4.1 SITE ASSESSMENT

The Charlotte Central School contracted with Dore and Whittier Architects, Inc. to perform a comprehensive review of the school facilities and make recommendations with regard to structure and system improvements. Donald L. Hamlin Consulting Engineers has provided civil engineering and permit compliance assistance to the Charlotte Central School for over 20 years and so was retained directly by the school for the civil/site portion of the review due to their in depth knowledge of the site and systems outside of the school building. The following is a summary of their recommendations related to grounds and systems outside of the building envelope.

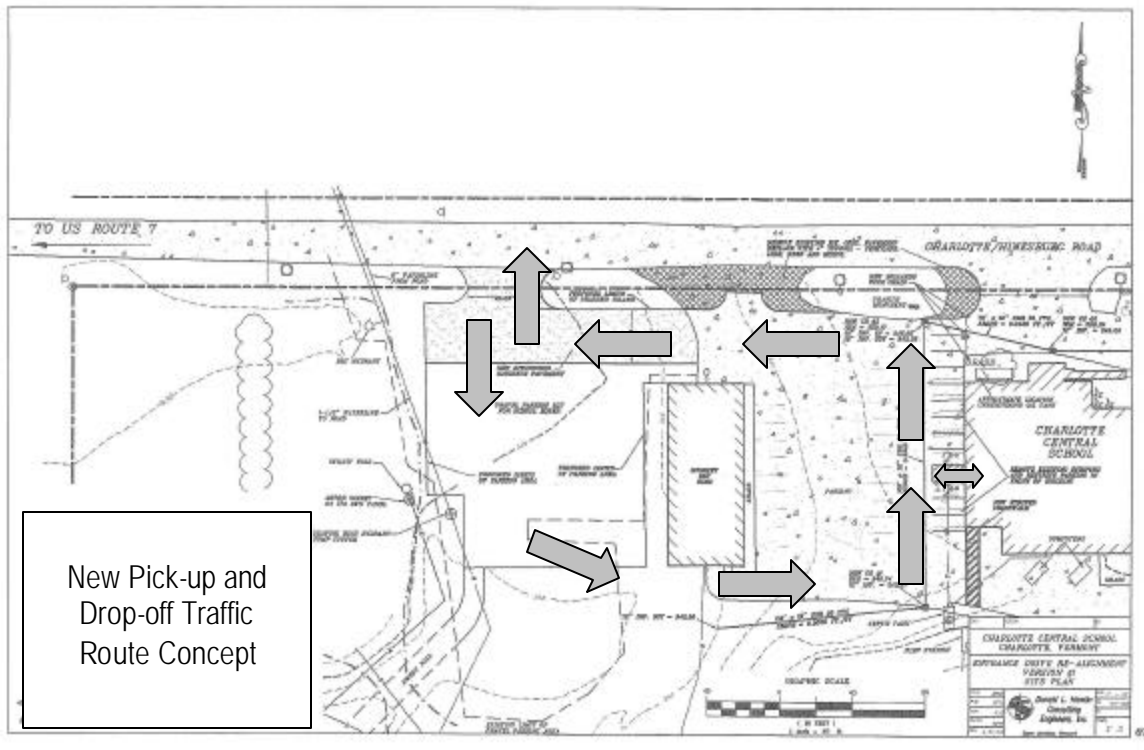
system that was permitted by the State in 1987. After approximately five years of monitoring, the system was transferred into the State's Indirect Discharge Permit program, which requires that system flows be tracked on a daily basis and flow records sent to the State on a monthly basis. The permit also requires that there be an annual inspection of the system and a report submitted to the school and the State reflecting the findings of the inspection and recommended maintenance or repairs. Currently the permit limits the total flow to the field to 6,000 gallons per day of effluent. Should the actual flow reach a three month average that is 80% of this value, or should the waste strength exceed 80% of the limits described in the permit, the school must commence the search for a new leach field location. As mentioned previously, the water meter and pump timer meters are read daily to check the flow and twice a year samples are taken to determine the waste strength of the effluent. Neither 80% threshold, for either the waste quantity or strength, has been triggered to date. It our understanding the school population is predicted to decrease in the immediate future. Aside from normal maintenance such as pumping the septic tanks, pump replacement, and cleaning the system piping, the system has worked very well since its installation. Minor pressure piping modifications were recommended as a part of this year's annual inspection and report and these repairs have been scheduled to be completed prior to the start of the 2007-2008 school year. Although not improving function of the system itself, one modification that would make operation of the system easier for the custodial staff would be to relocate the pump control panel. Currently the pump control panel is located in room adjacent to the kitchen that is used to store dry and canned foods. The pump control panel is located in the corner of the room and often has pallets of food placed in front of it. See photo below:

This of course makes required daily access to the pump control panel very inconvenient. Compounding the daily access problem, the pump station alarm is a visual alarm that lights should there be a problem with the pump station and there is no audible component to the alarm. With food stored in front of the panel, the visual alarm is often not visible. Beyond these practical matters is the health concern of service people who are working on the sewer pump station needing access to the control panel to turn off or test the pumps having to walk through the food storage area. We would recommend , and Head Custodian Labonte concurs, that the pump control

panel should be relocated out of the food storage area and to a more accessible location, perhaps within the custodian's office and it should be fitted with an audible alarm.
